SPRINGS LOFTS

RFI#: 37 Date: 1/23/2012 Job: EB-02 Keller Springs Lofts Phone: 877-777-5115

Date Required: 1/25/2012 Request: On sheet P-3.0C the main sanitary trunk line is shown running in the center of the corridors. It is 6" running north along the east side of the garage. It joins another 6" running east along the north side of the garage. So we have a 6" joining with another 6" but there is no designation as to the size of the line after that until it meets the 10" that leaves the building. Sheet P-3.0E gives no designation to the size of this line either. I feel this may be an oversight and the intention would be to have the large to an 8" after the (2) 6" lines merge. Please advice and respond as we are going to be installing these lines in the next two days.

Drawing: P3.5A, 3.5A

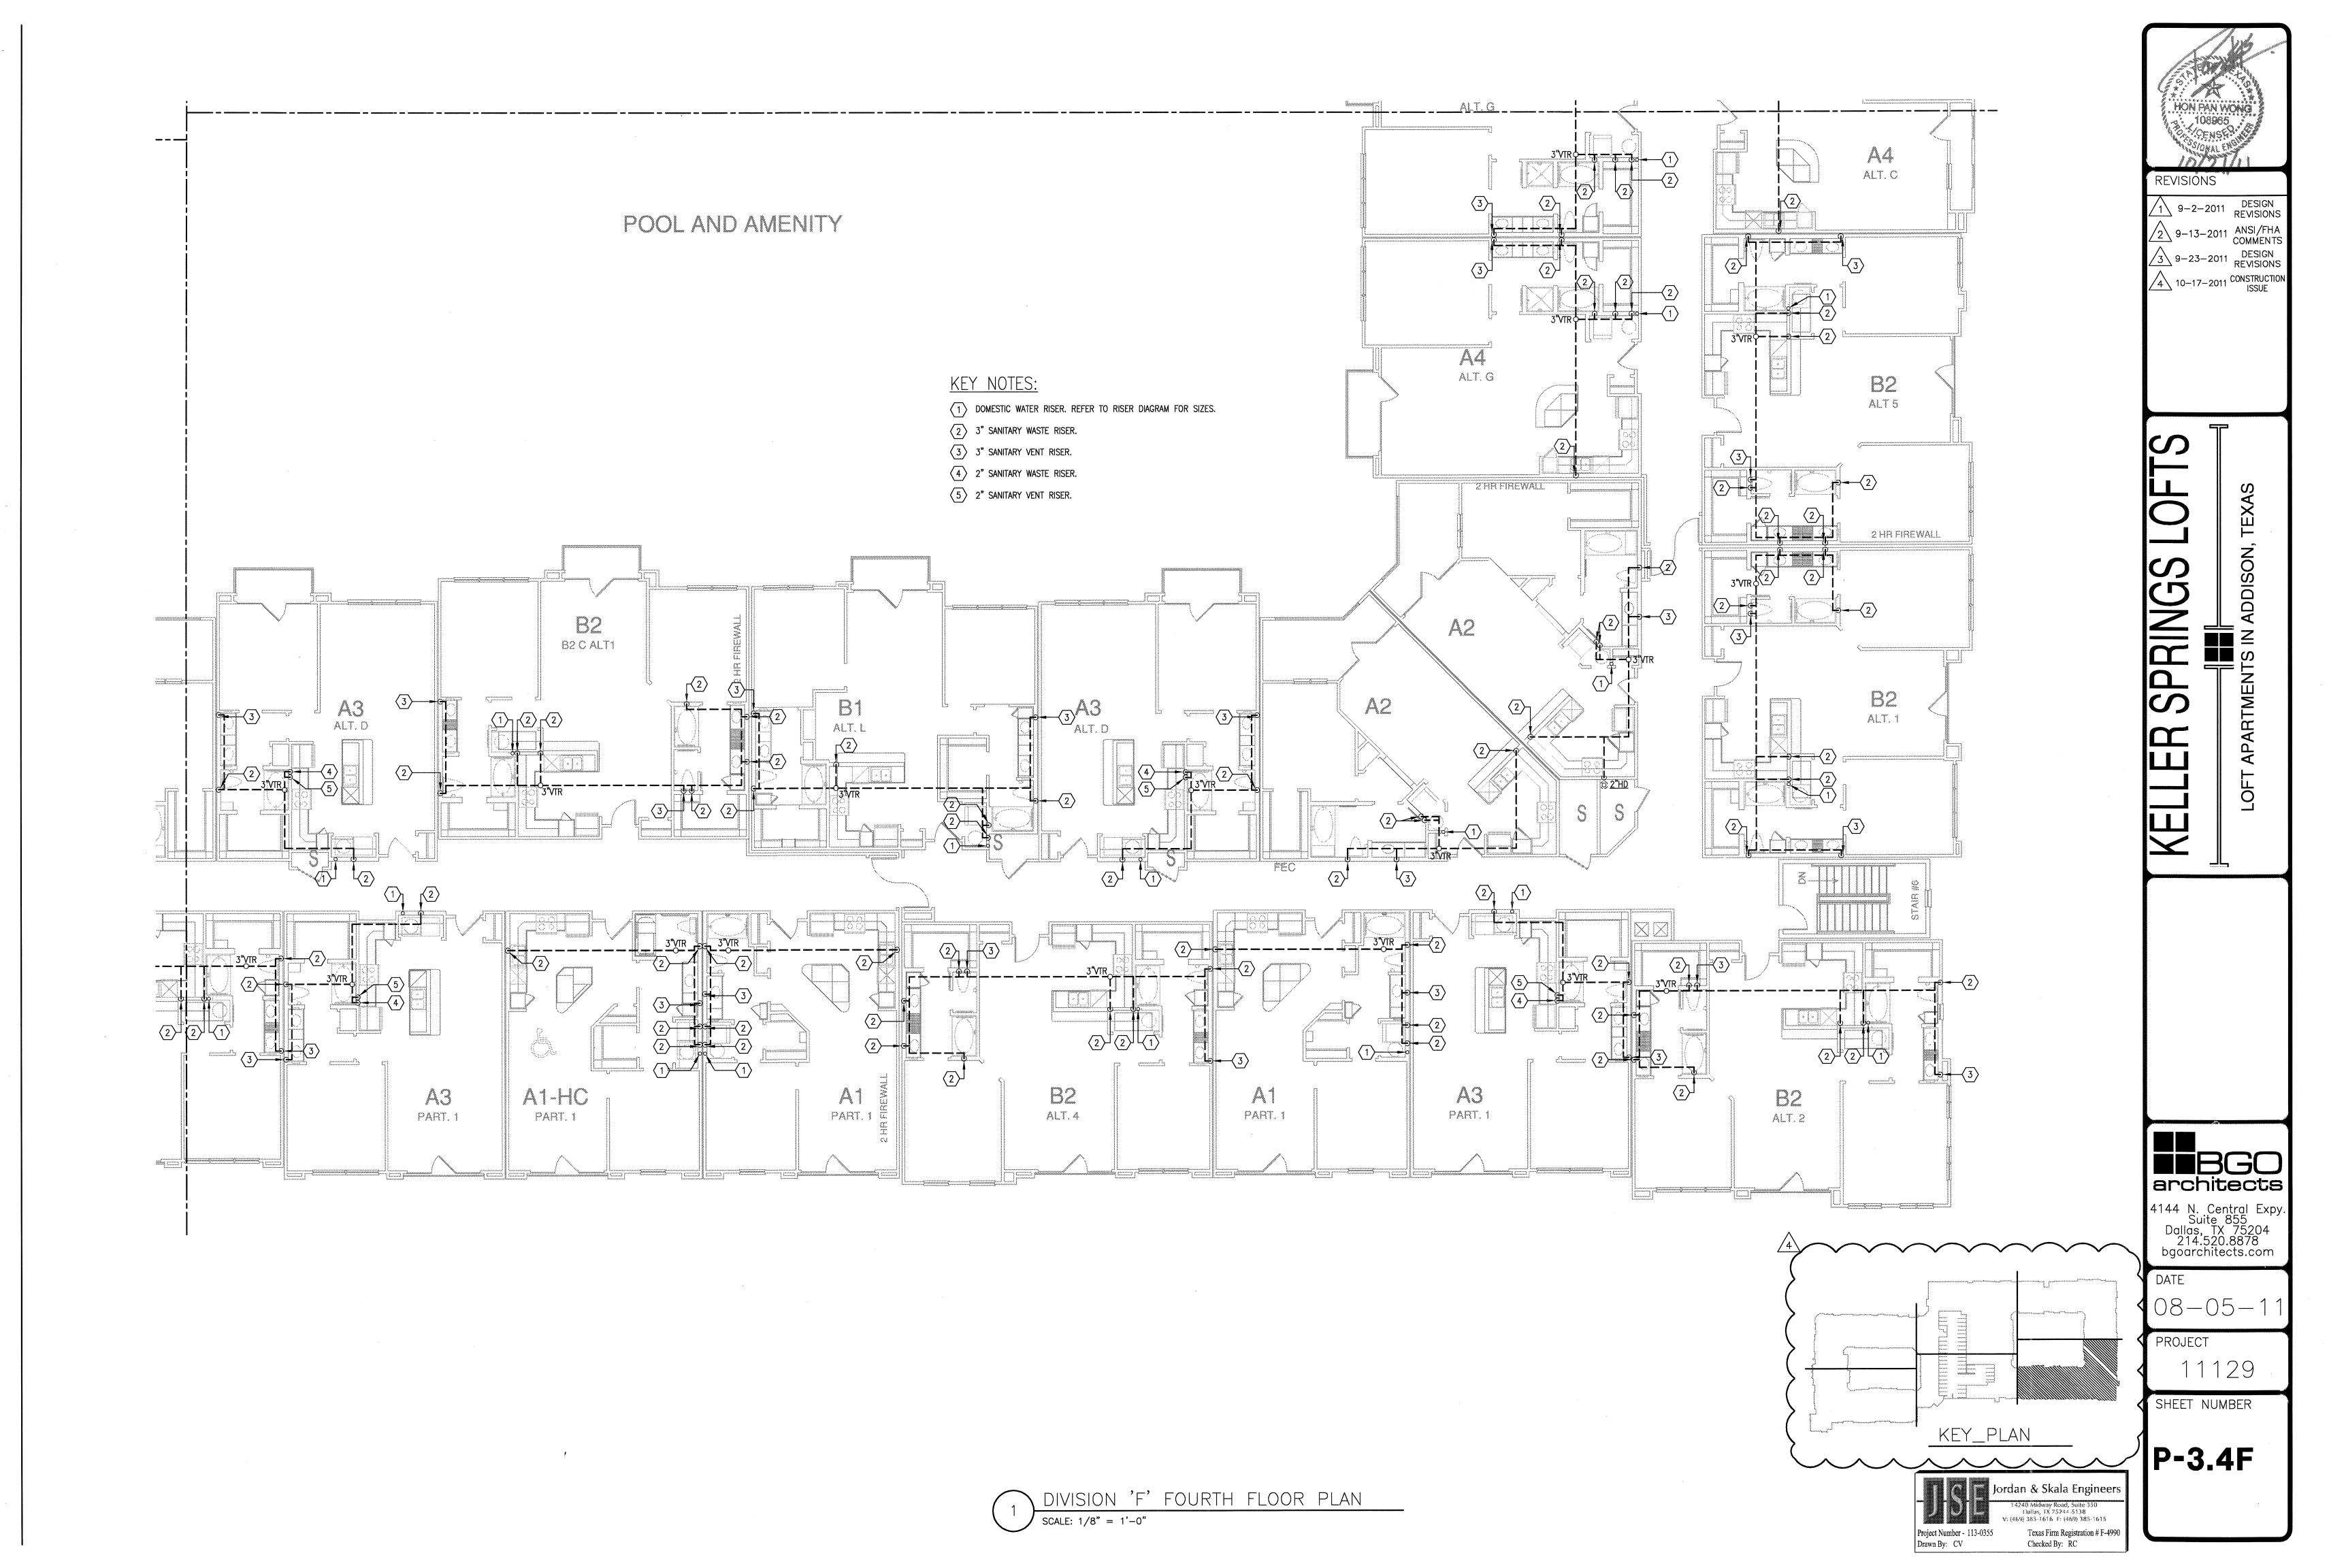
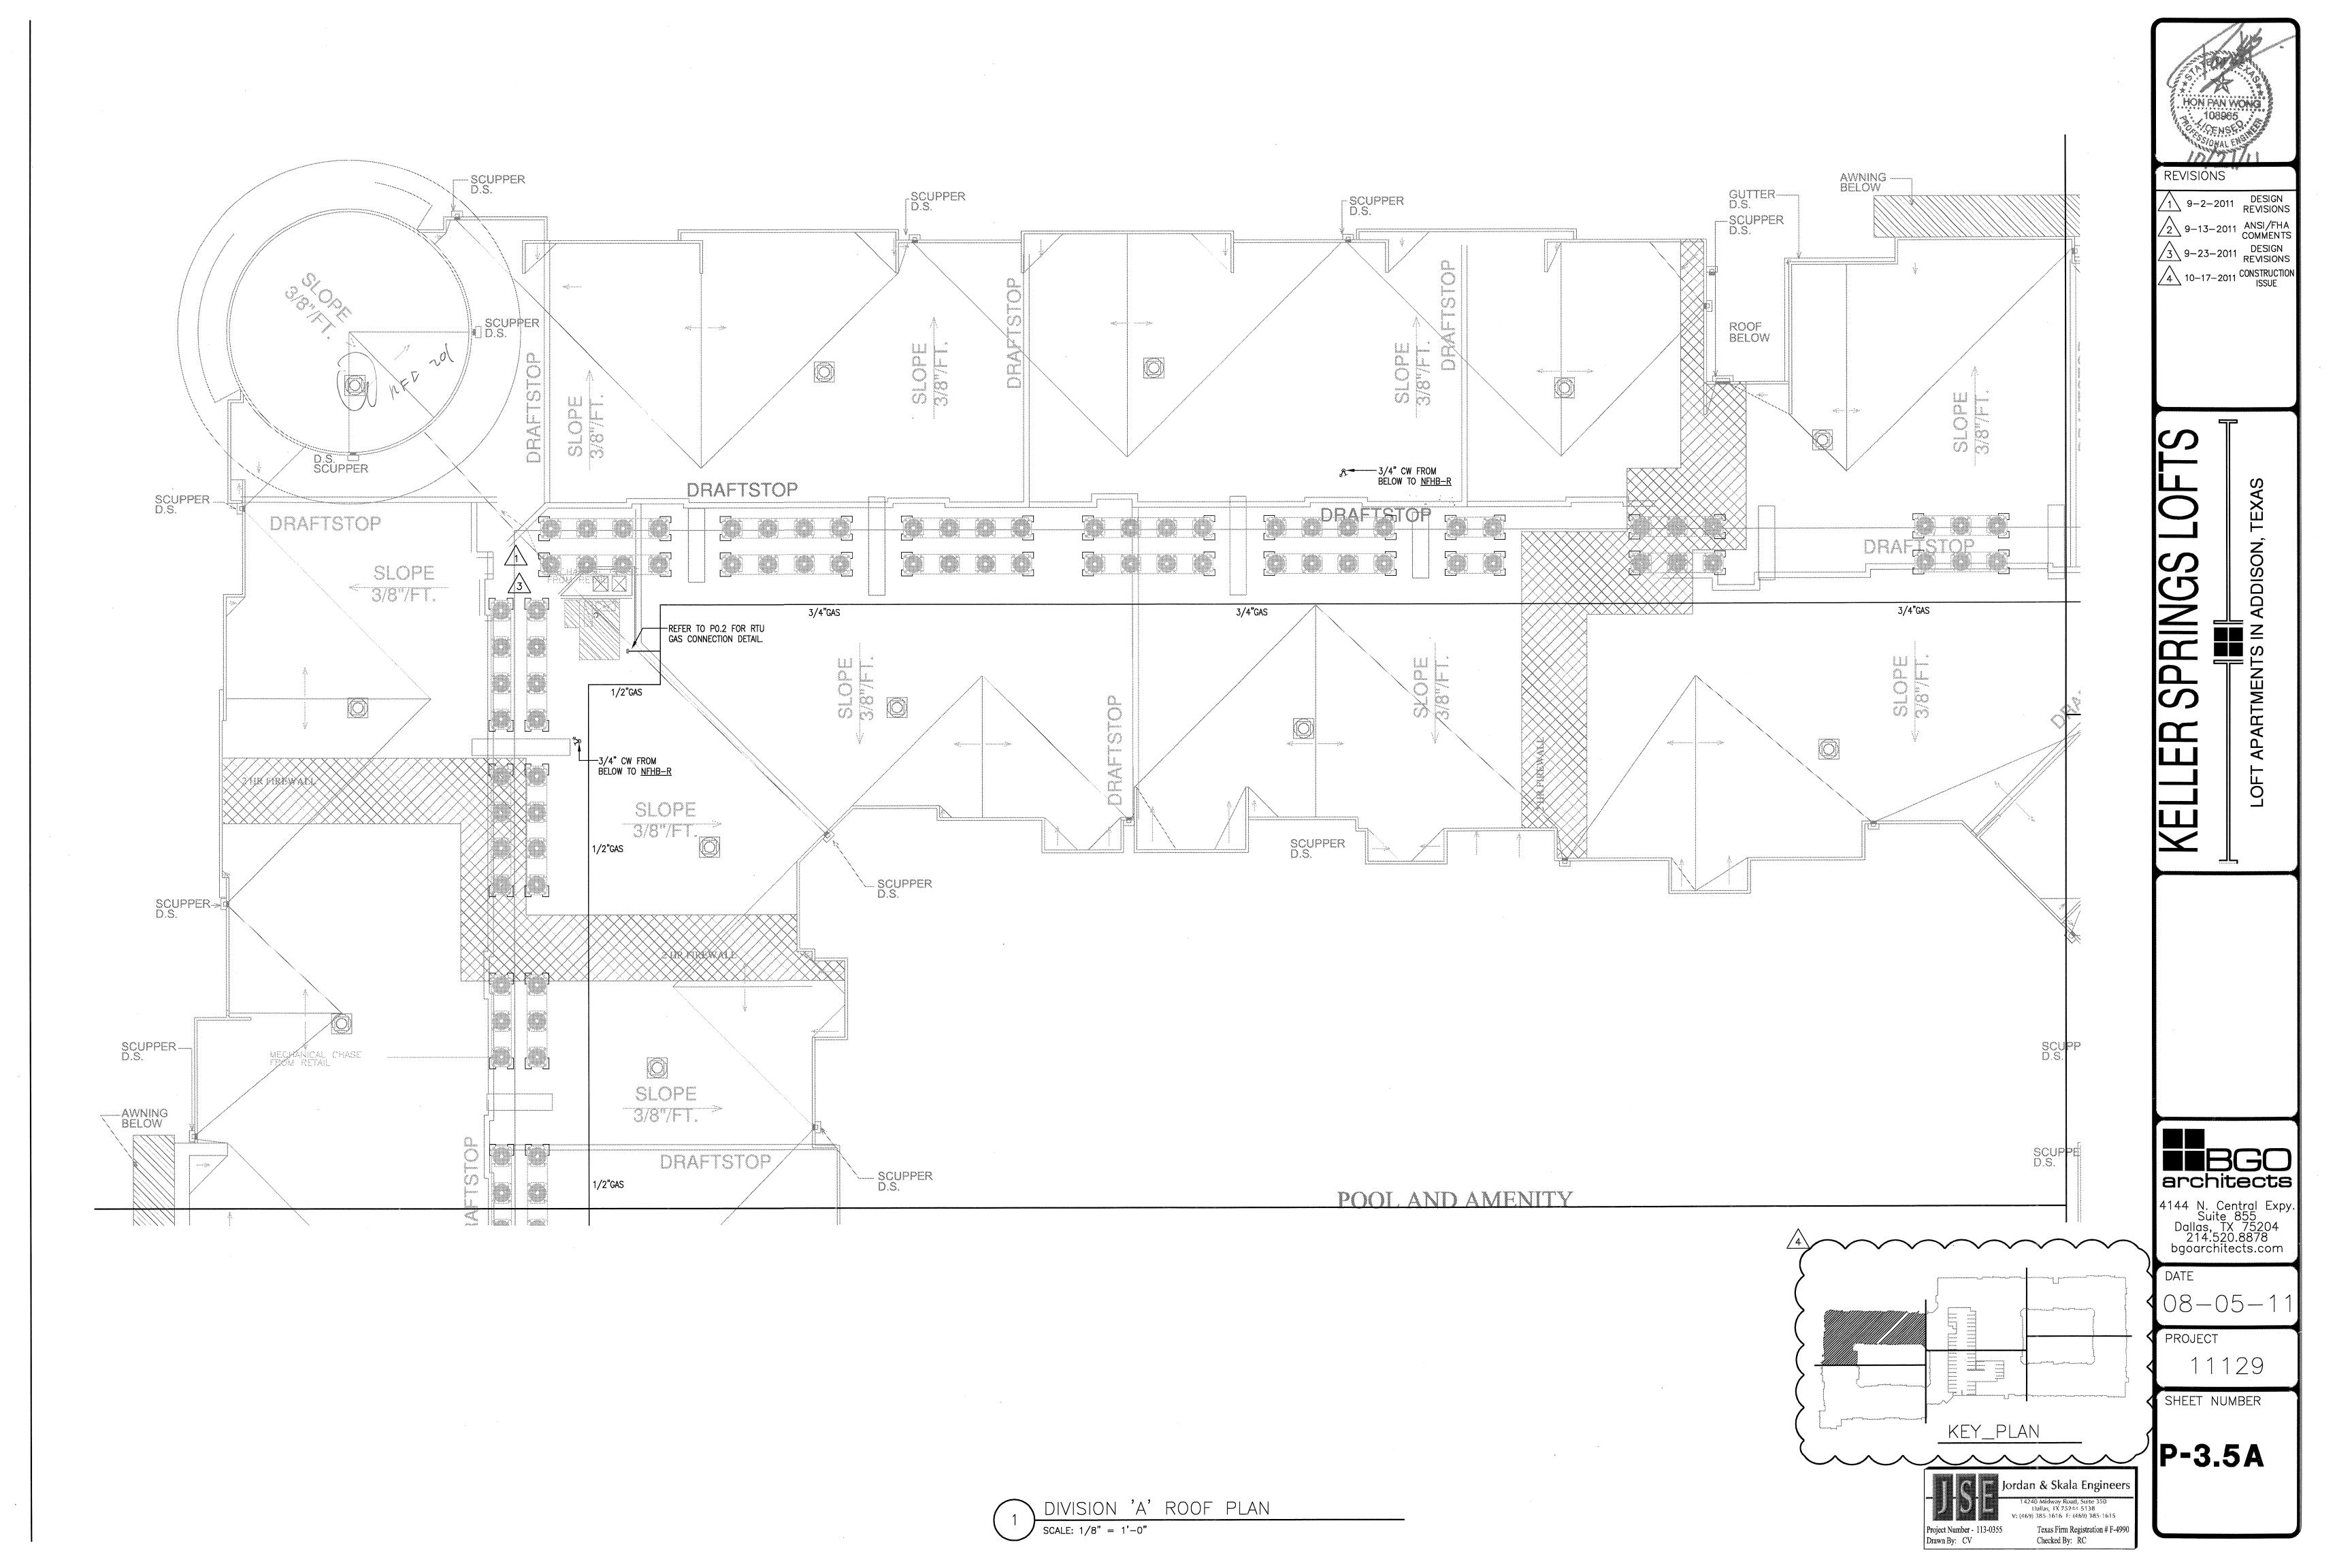
Date Required: 10/26/2012 During an on-site meeting with Walter Kilroy and Ryan Faulds of BGO Architect it was determined that we would use a drain and overflow on top of the radius located on the northwest corner of the west building. The plans showed (2) scuppers with downspouts which would not work because of the exterior angle on the radius feature. It was decided that the drain line would be located inside the radius tower until it penetrated the side of the radius tower just about the stucco receiver and drain onto the main roof. We will properly slope the roof and build crickets for the water to enter the drain. Please size and detail the drain and drain lines Jordan & Skala deems appropriate for this task. Request:

it is recommended that 4" drains and drian lines be used for the tower. Roof drain shall be Jay R. Smith #1015 or equal and overflow drain shall be Jay R. Smith #1080 or equal. provide downspout nozzle Jay R Smith #1770 or equal at discharge point.
